***TECHNICAL SPECIFICATIONS
PUBLICATIONS LIST
RECALL CAMPAIGN
SERVICE BULLETIN INDEX***

**328 / 328
GTB / GTS**

Ferrari Servizio Assistenza Tecnica

FERRARI NORTH AMERICA

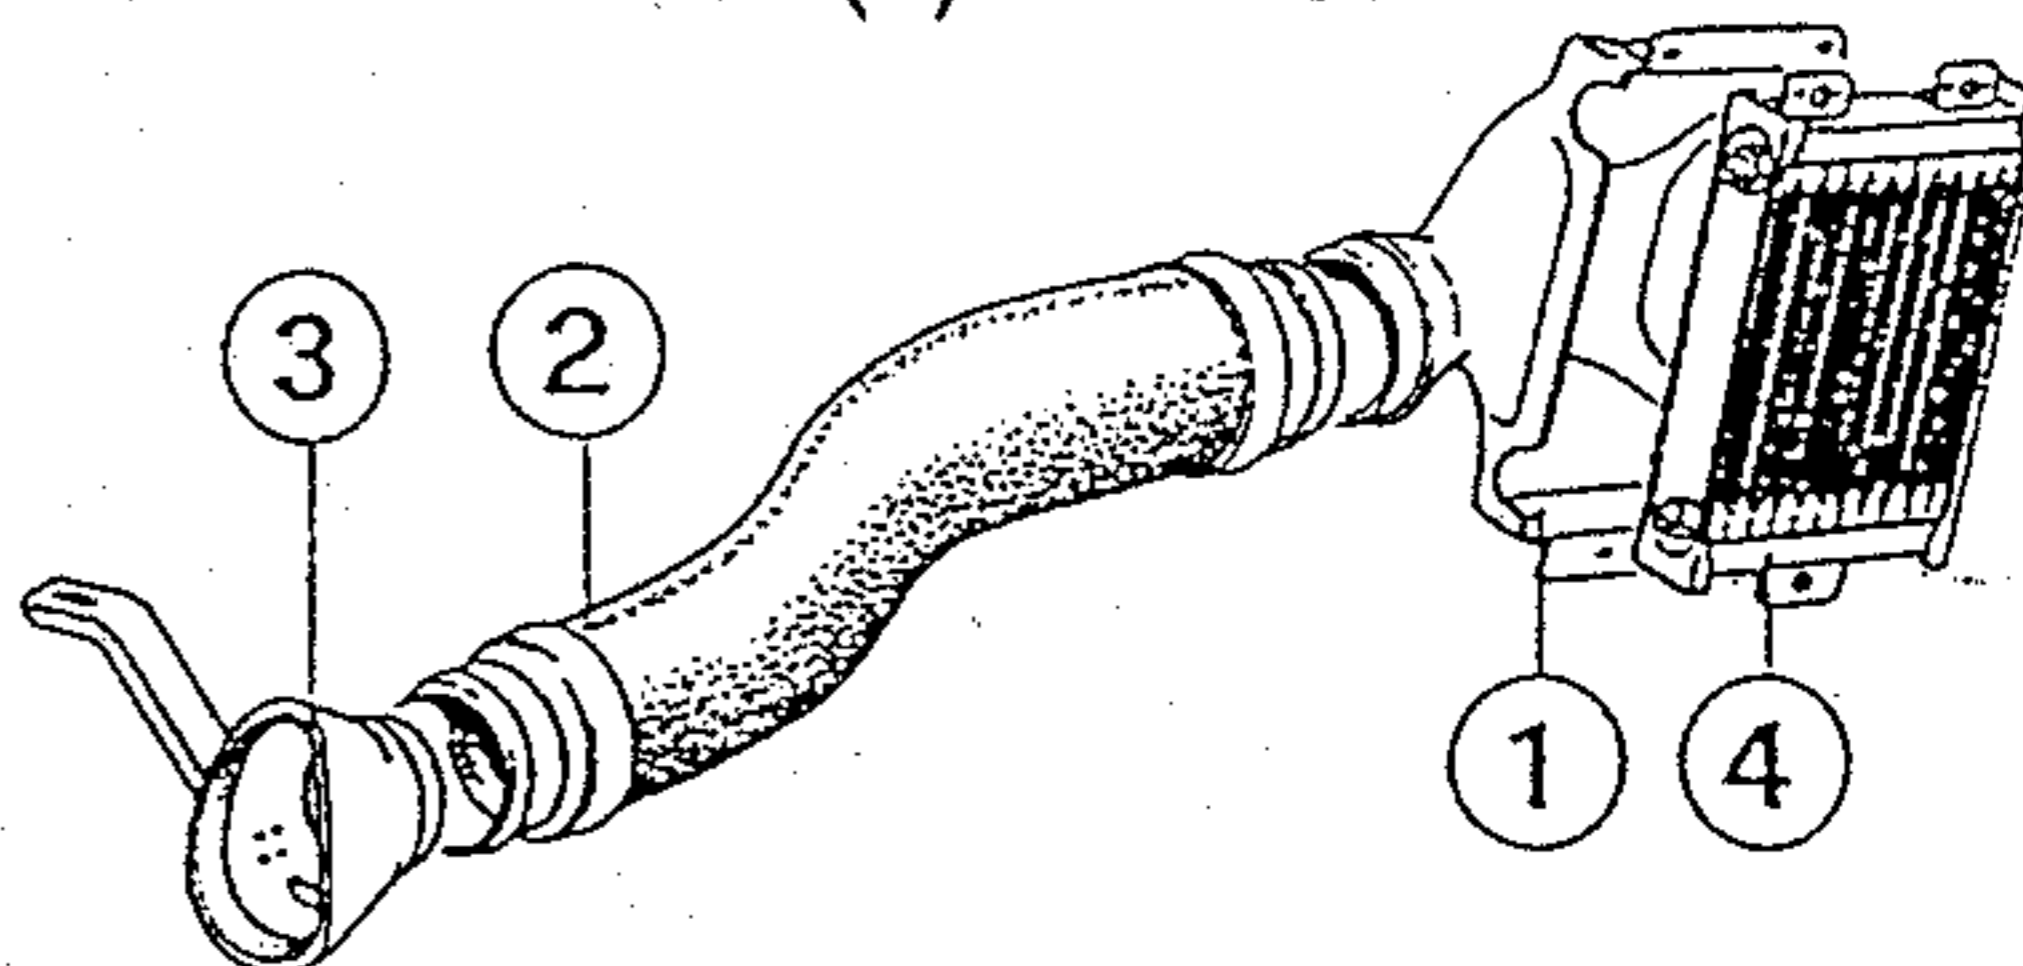
A new oil cooler air duct (3) is fitted to a new flexible tube (2) along with a modified conveyor (1). In addition, there is also installed a new oil cooler (4) P.N. 135774.

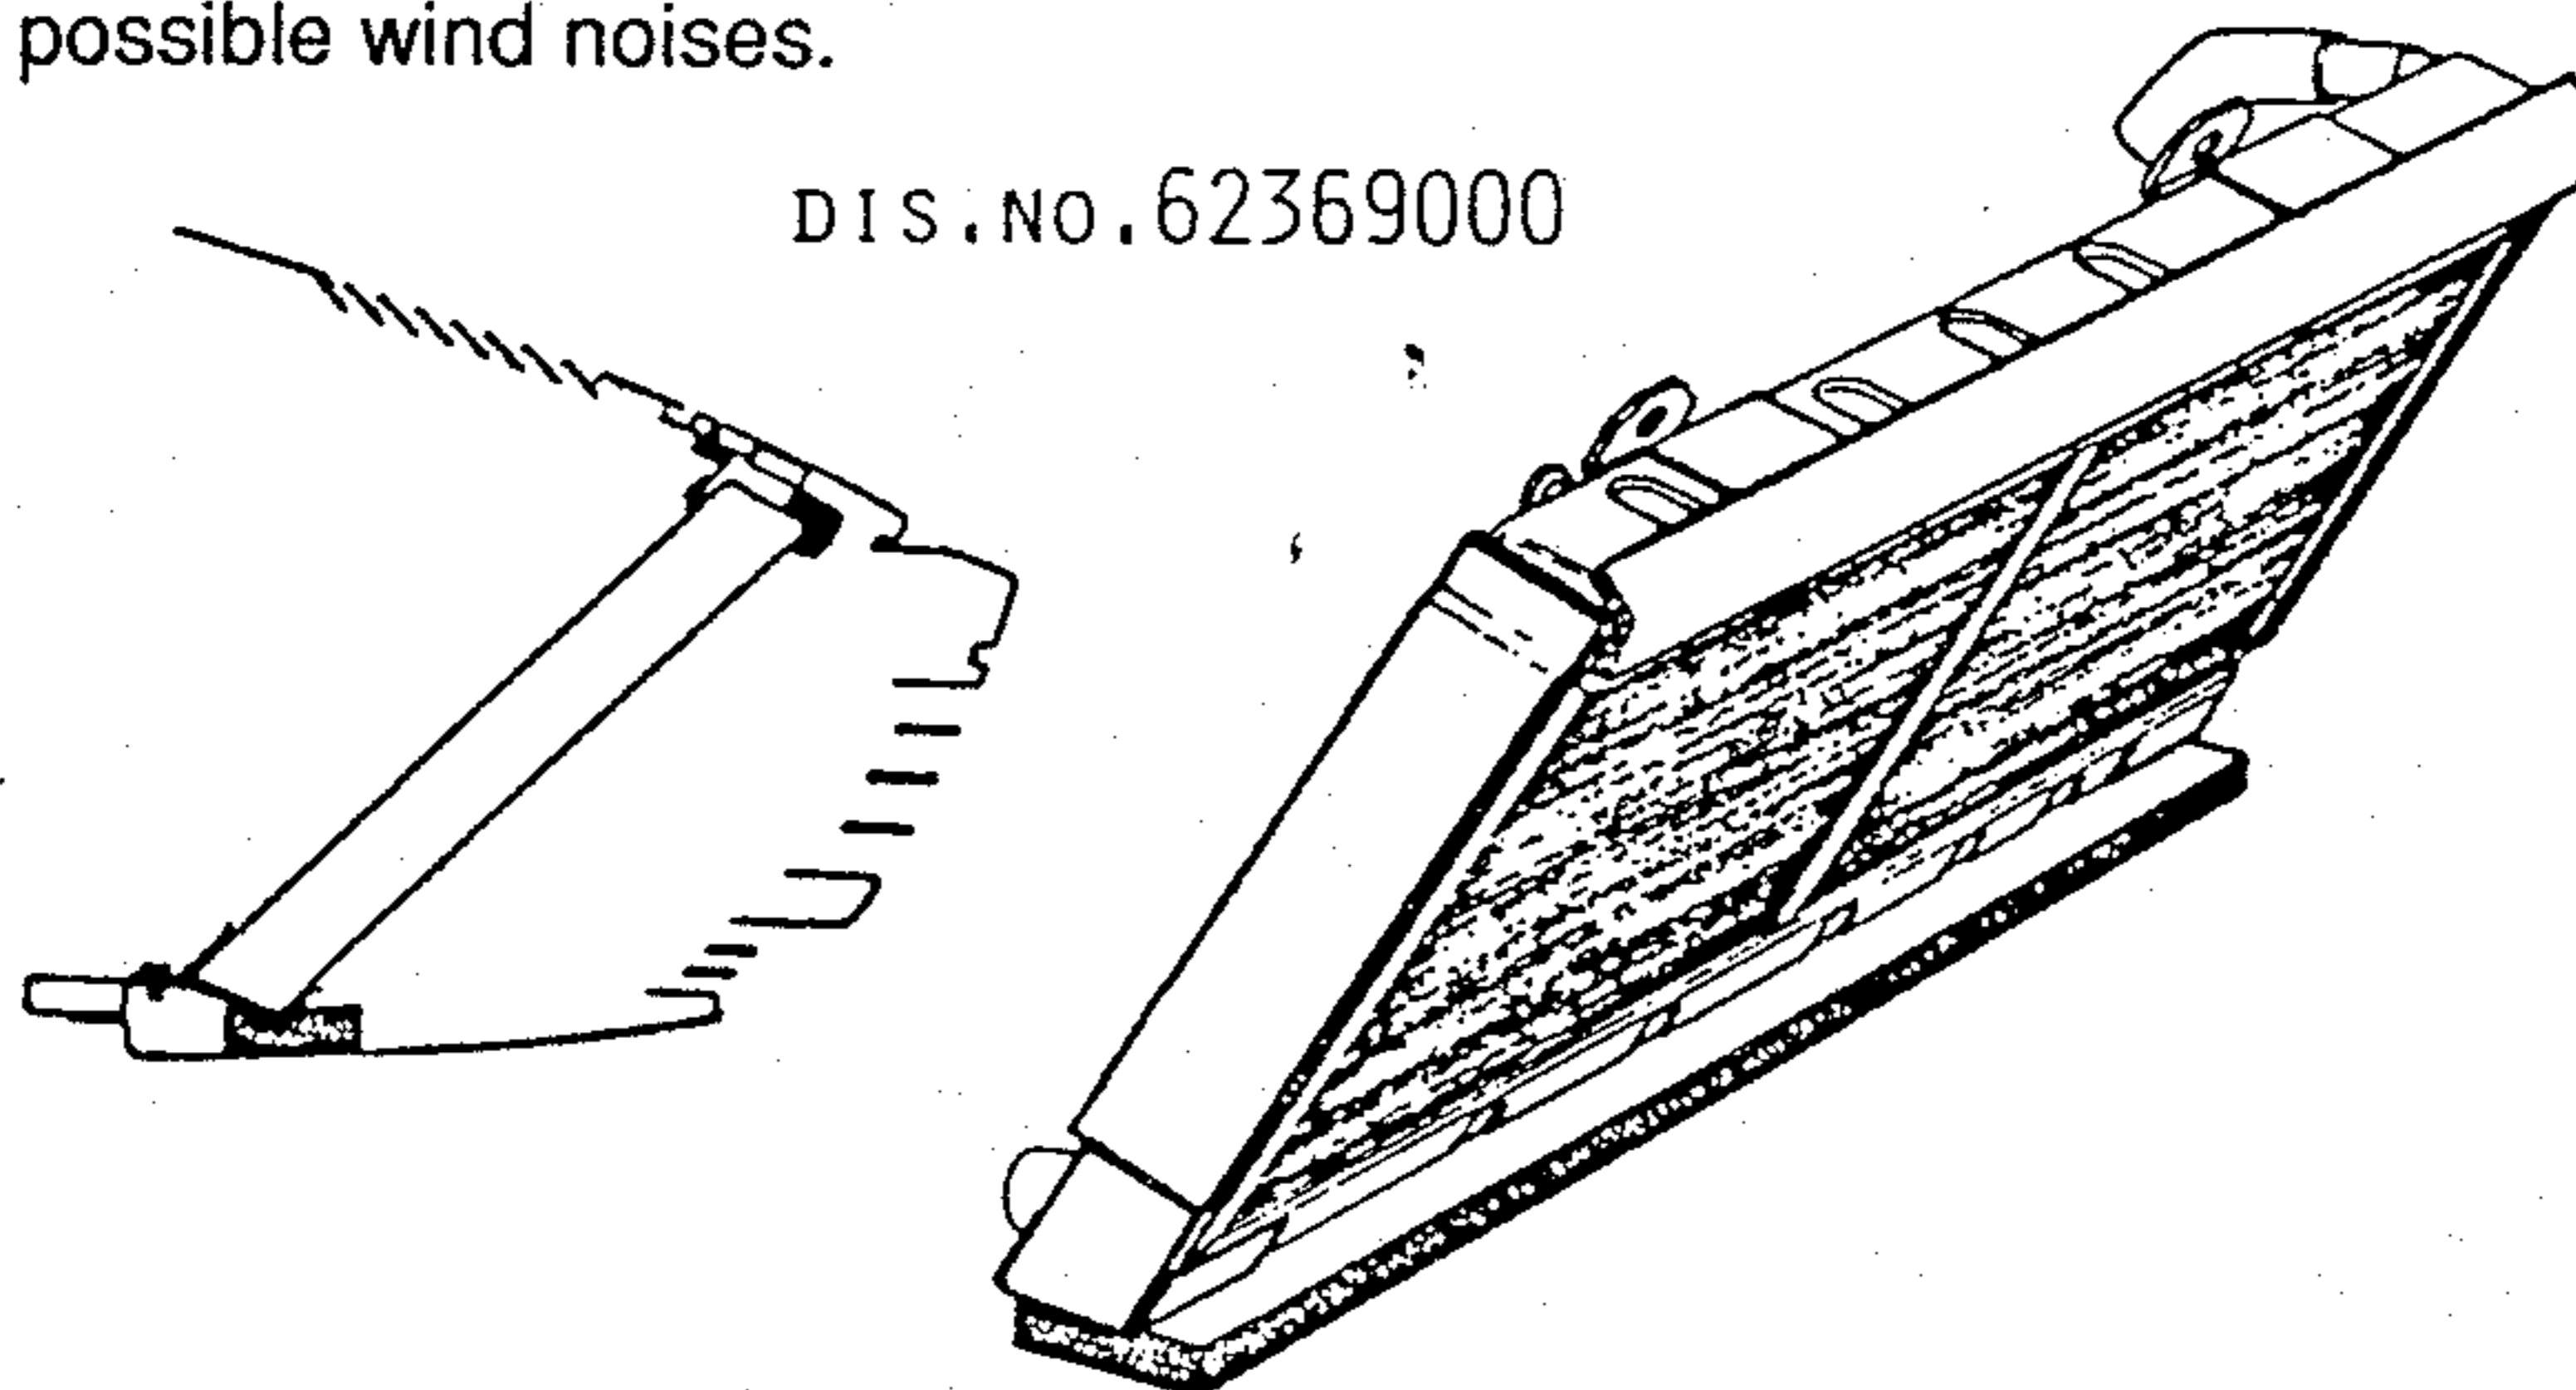
An additional gasket has been introduced on the upper edge of the water radiator as shown in the drawing.

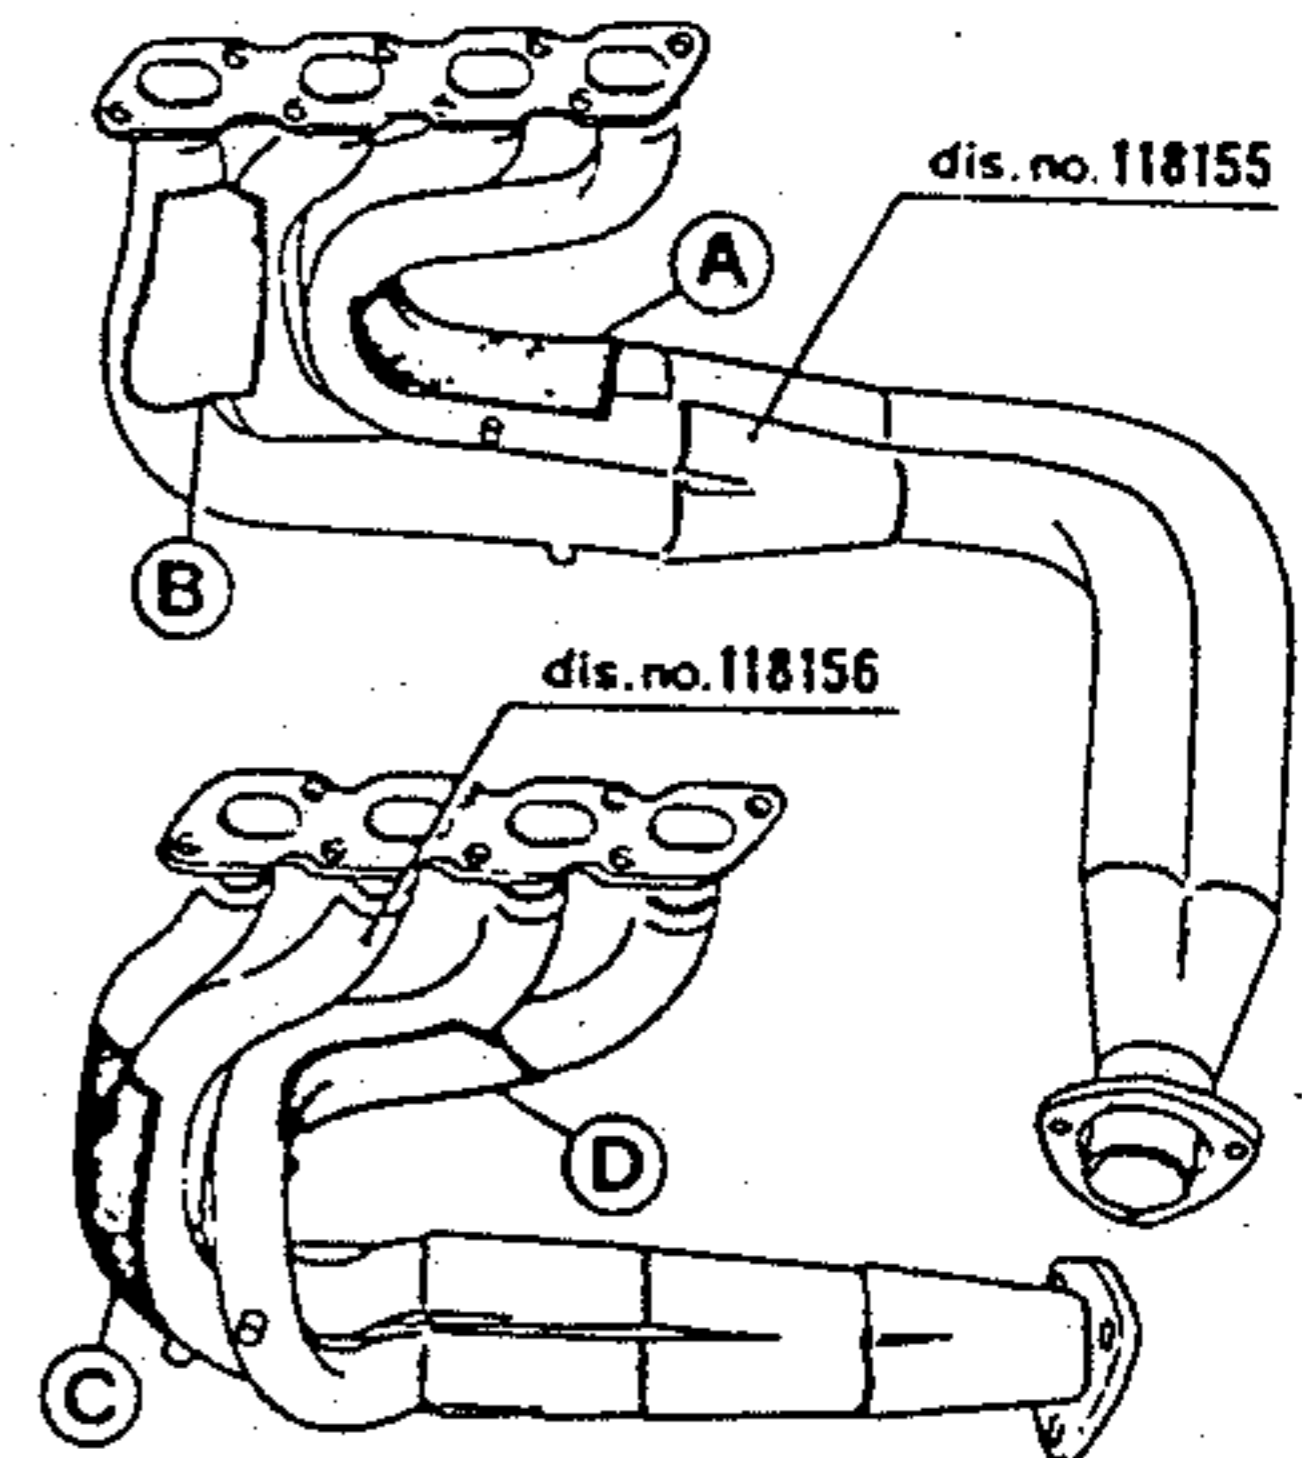
Modified exhaust manifolds, with additional gusset plates (A-B-C-D) are being used. The modified manifolds keep the same part number of the previous one (118155 - 118156).
